Access Compliance Report

Public Rights-of-Way

(Curb Ramps)

Intersection ID: 52929	Main Street: ENGLISH_OAK_LEAF_CT	Cross Street: GRAY_OAK_LN	Location: W
ADA ID: 198BDA389F71	Ramp Type: BlendTrans1	Initial Pass/Fail: Fail	Overall Compliance: No
Codes/Mitigation Info/Possible Solution			Severity Score: 10
			Field Measurements/Component Compliance

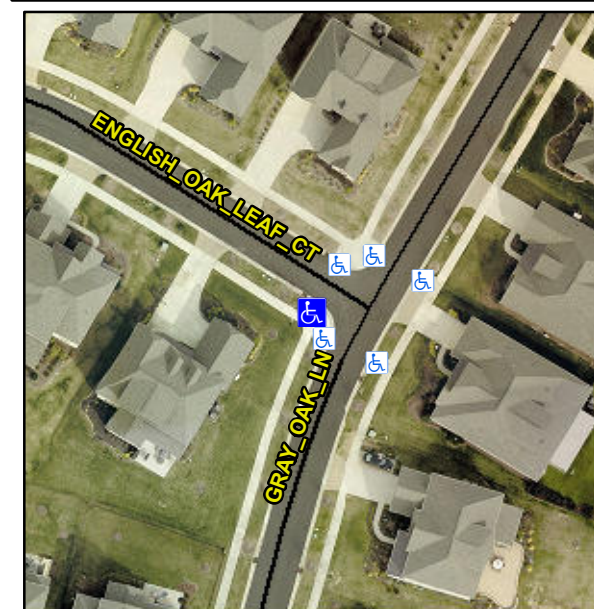
R304.5.1, R304.5.3

Compliance	Description	Data	Compliance	Description	Data
N/A	Ramp Length (in)	88.0	Yes	BlendTrans Slope (%)	1.6
No	Ramp Width (in)	47.5	No	BlendTrans XSlope (%)	4.8
N/A	Flare Type LT	N/A	N/A	Flare Type RT	N/A
N/A	Flare Slope LT (%)	N/A	N/A	Flare Slope RT (%)	N/A
N/A	Flare Traversable LT?	N/A	N/A	Flare Traversable RT?	N/A
N/A	Landing Length (in)	N/A	N/A	DWS Provided?	N/A
N/A	Landing Width (in)	N/A	N/A	DWS Contrast?	N/A
N/A	Landing Slope (%)	N/A	N/A	DWS Length (in)	N/A
N/A	Landing X Slope (%)	N/A	N/A	DWS Full Width?	N/A
N/A	Landing Curb? (Y/N)	N/A	N/A	DWS Offset (in)	N/A
N/A	Shared Landing?	N/A			
N/A	Gutter Ponding?	N/A	N/A	Gutter Slope (%)	N/A
N/A	Gutter Lip Ht (in)	N/A	N/A	Gutter X Slope (%)	N/A
N/A	Painted X Walk1?	No	N/A	Painted X Walk2?	N/A
	X Walk 1 Direction	To NE		X Walk 2 Direction	N/A
	X Walk 1 Width (in)	N/A		X Walk 2 Width (in)	N/A
	X Walk 1 Slope (%)	1.0		X Walk 2 Slope (%)	N/A
	X Walk 1 X Slope (%)	2.5		X Walk 2 X Slope (%)	N/A

Remove & Replace Curb Ramp With Two New Directional Ramps or Equivalent.
